DANE COUNTY DEPARTMENT of PUBLIC WORKS, HIGHWAY and TRANSPORTATION

RFB NO. 313083 - ADDENDUM NO. 3

CONSTRUCTION OF EAST HIGHWAY GARAGE – SALT STORAGE FACILITY (BID PACKAGE A) AND MEDICAL EXAMINER OFFICE BUILDING (BID PACKAGE B)

**DEPARTMENT OF PUBLIC WORKS,
HIGHWAY & TRANSPORTATION
3562 COUNTY HIGHWAY AB
MCFARLAND, WISCONSIN**

Sheet A-213 – Fuel Island Plans

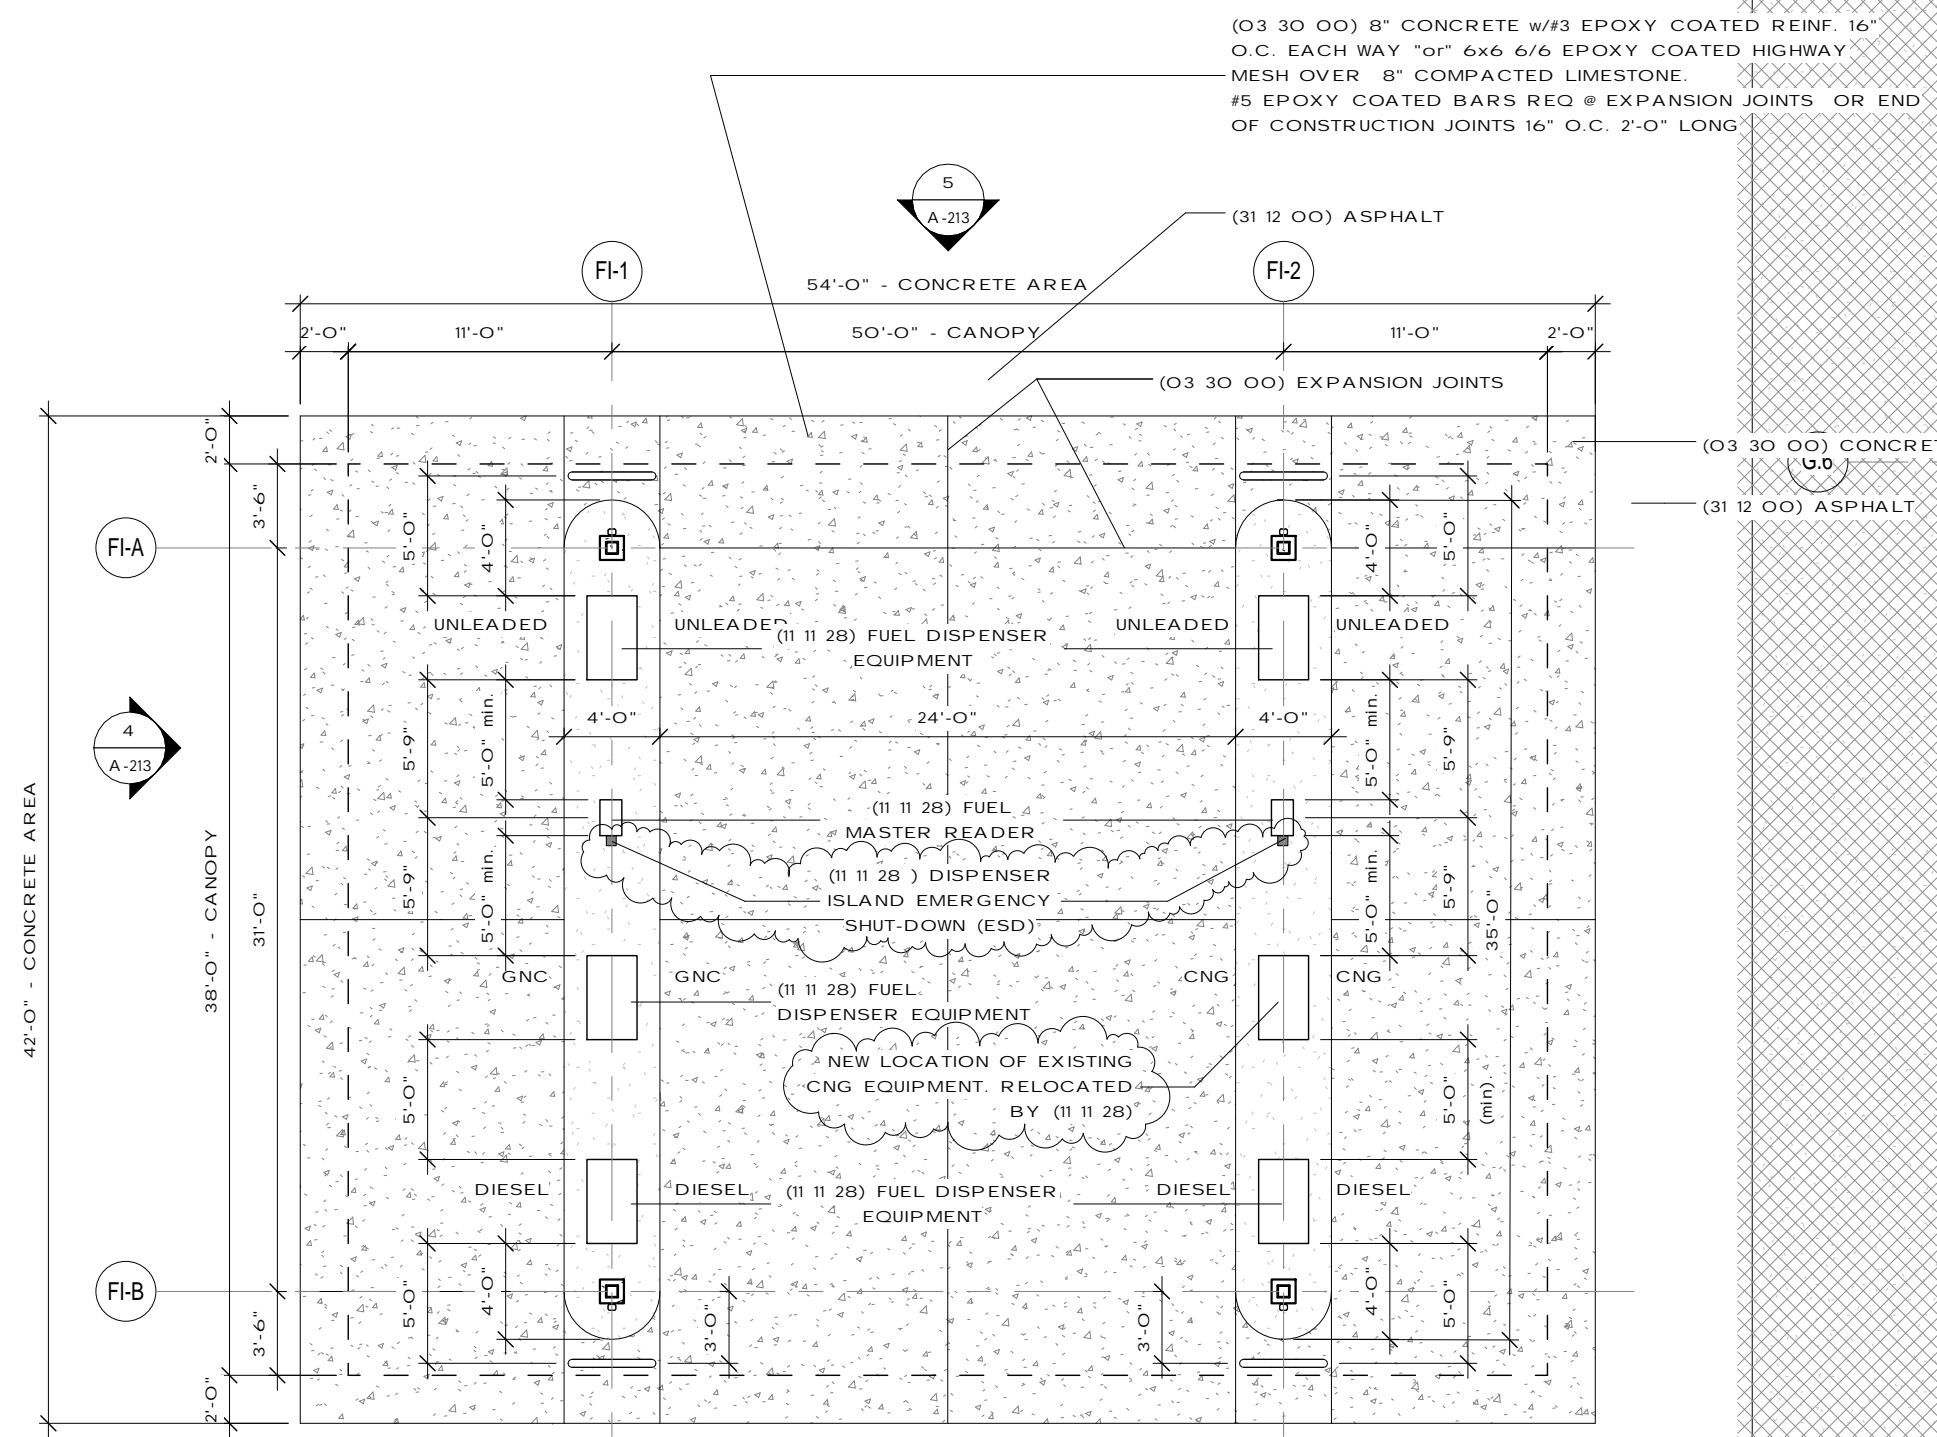
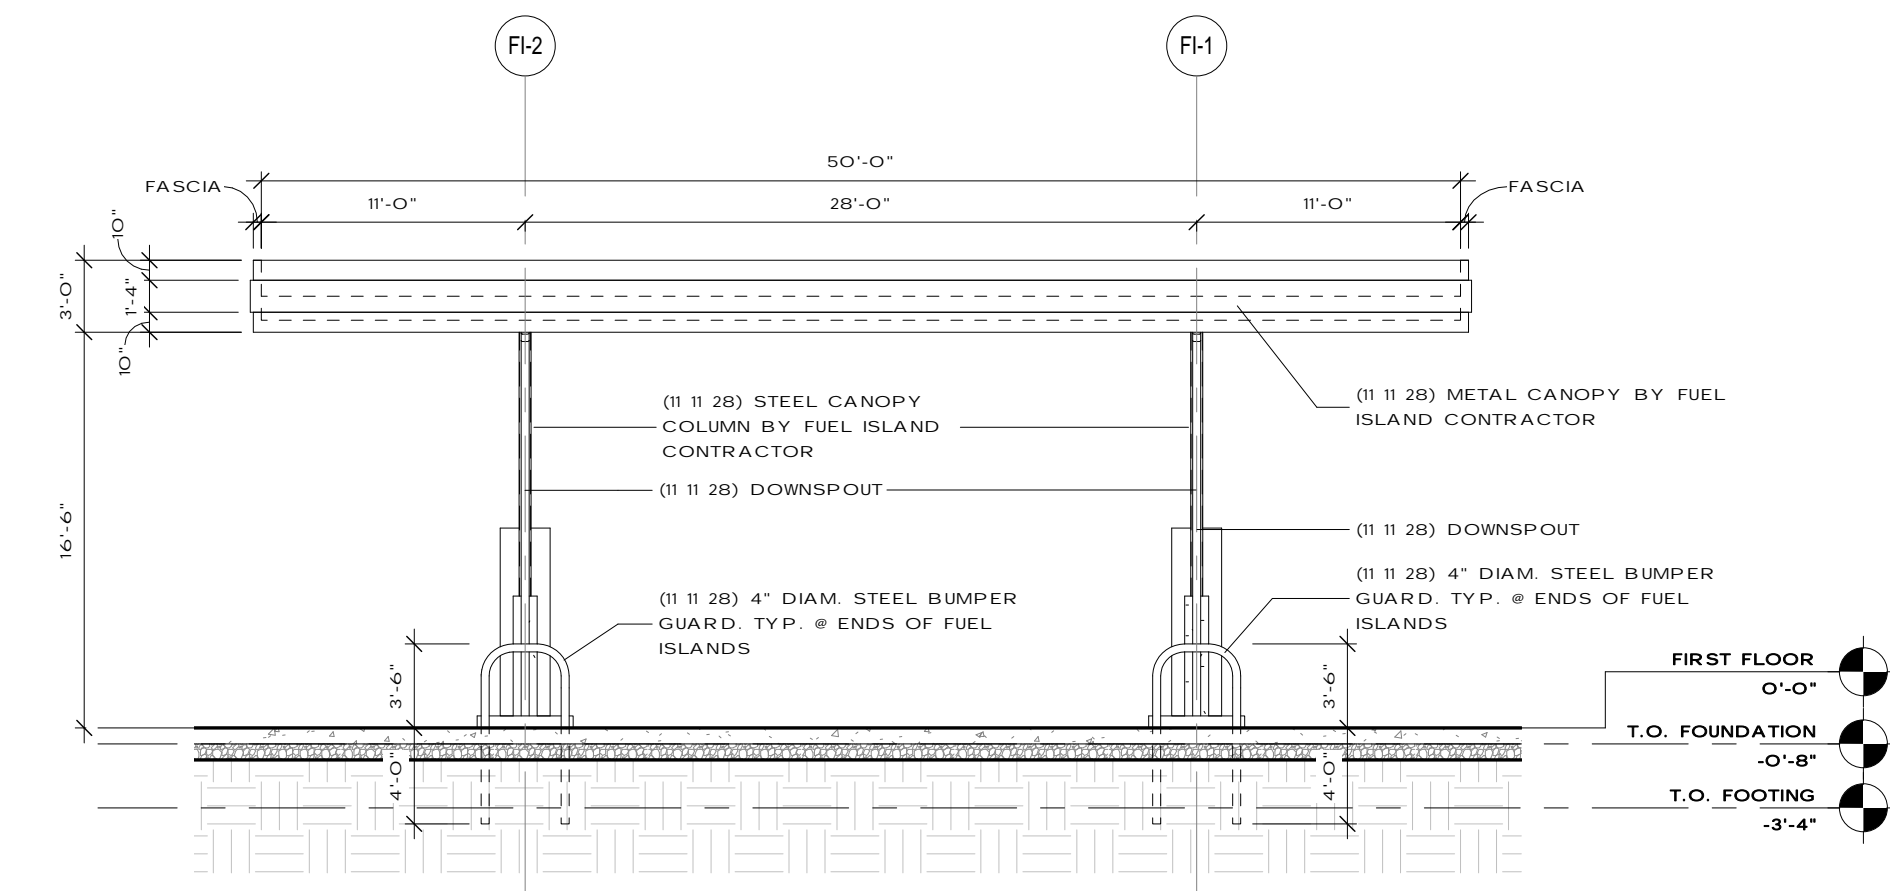
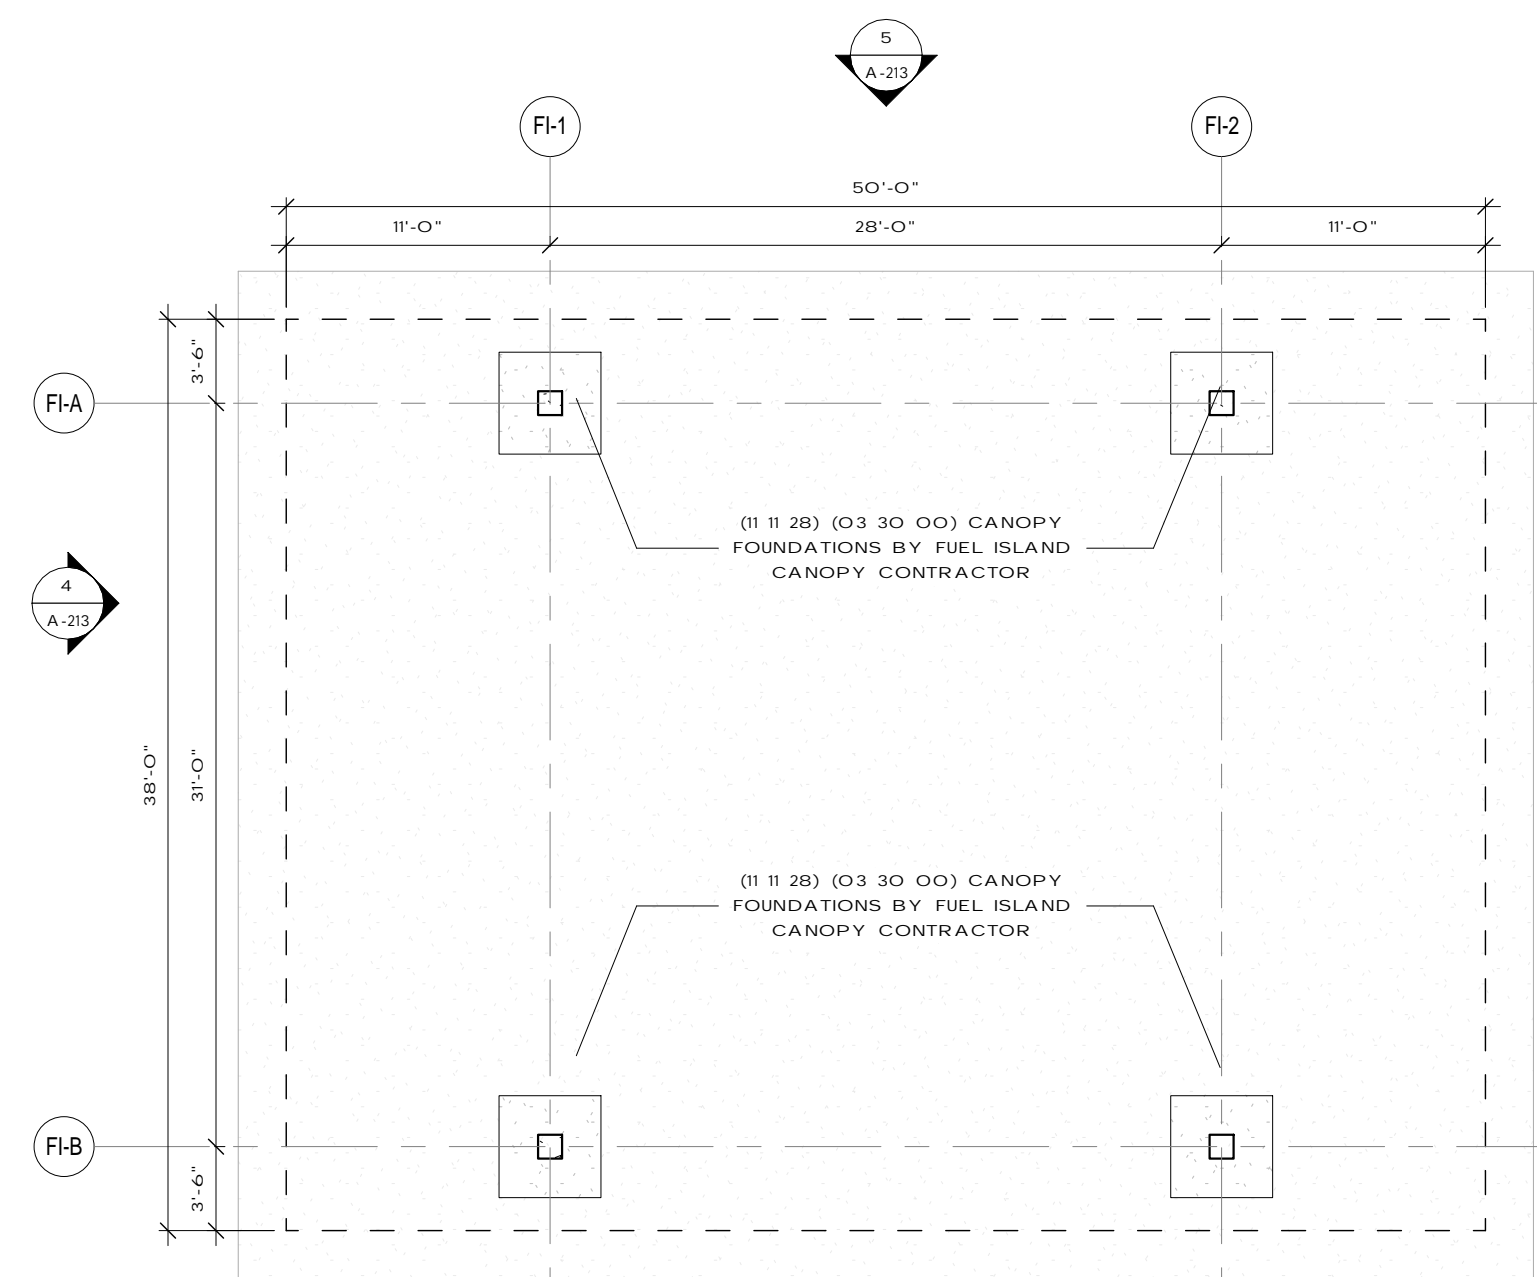
2. Paragraph 2.1 C – Specification states “Six (6) total dispensers required at the Fuel Island.” To clarify, two dispensers are for unleaded, two dispensers are for diesel, one dispenser is an existing CNG dispenser, and one dispenser is a new CNG dispenser. See Sheet A-213, revised as part of the addendum.

1. See revised sheet included in this addendum for revisions and clarifications to the fuel island area.
2. Elevations: Additional extruded canopy band shown is not necessary. A 36" flat fascia panel is acceptable. Panel color to be from manufacturer's standard range, tan or beige.
3. Underground fuel tanks have been rotated 90 degrees.
4. Install concrete pavement in the fuel island area in lieu of asphalt paving shown. See revised Sheet A-213.
5. Concrete pad under relocated CNG equipment shall be as detailed on revised Sheet A-213. The same pad detail shall apply to the backup generator pad and control panel pad.
6. Provide twelve (12) 6" pipe bollards per Detail 14/A-502 spaced equally along the edge of the CNG equipment pad to protect from traffic. Provide two (2) 6" pipe bollards at CNG Control Panel Pad. This work is to be done by the Fuel Contractor.

7. Of the two CNG dispensers shown, one shall be a new dispenser; one shall be an existing dispenser. Existing dispenser shall be relocated from the adjacent landfill.
8. Complete startup of the existing CNG system will be the responsibility of the Fuel Contractor. Any damage or disrepair as a result of the system being unused for the past twelve months will not be the responsibility of the Fuel Contractor.
9. Natural Gas service with a separate meter will be provided to the fuel island area as shown on Sheet A-213.
